3/4.3.2 ISOLATION ACTUATION INSTRUMENTATION

TABLE 3.3.2-3

## ATTACHMENT C

### EVALUATION OF SIGNIFICANT HAZARDS CONSIDERATION

TABLE 3.3.2-3

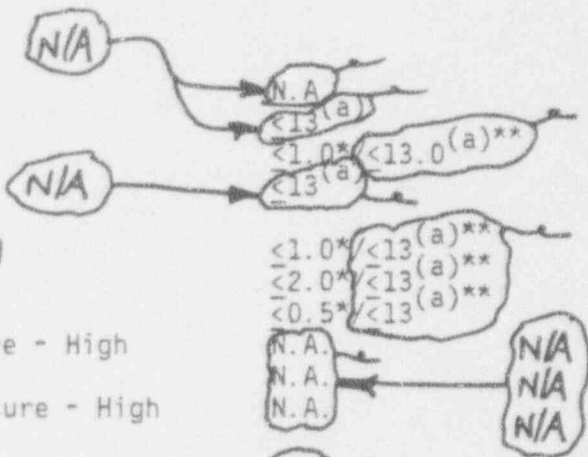
The proposal seeks to eliminate response time testing requirements for selected instrumentation in the isolation system. The proposal does not introduce changes in the response times themselves. The probability and consequences of an accident previously evaluated are not increased because accepted licensing criteria are maintained. The requirements for channel checks, functional tests, calibrations, and logic system functional tests are not altered by this proposal. The ability to detect degrading trends of response times is available via the above Technical Specification required tests. Therefore, the response times of these systems will be maintained within the acceptance limits assumed in plant safety analyses and required for successful mitigation of an initiating event because of the continued Technical Specification testing.

The proposal does not change component or system interactions. Accident analyses assume a loss of AC power which is restored by startup of emergency diesel generators. The 13 second interval associated with the restoration of AC power, which establishes the response time for the isolation functions, is maintained. The starting, sequencing, and loading functions associated with the diesel generators is not affected by the proposed change. The response times include the instrument response times, which are typically measured in fractions of a second, and the response times of the actuation logic circuits, which are typically less than a second. These times are small in comparison to the diesel generator start time (13 seconds). The ability of the isolation system to perform its intended function to mitigate the consequences of an initiating event within the acceptance limits assumed in plant safety analyses is not altered by the proposed change.
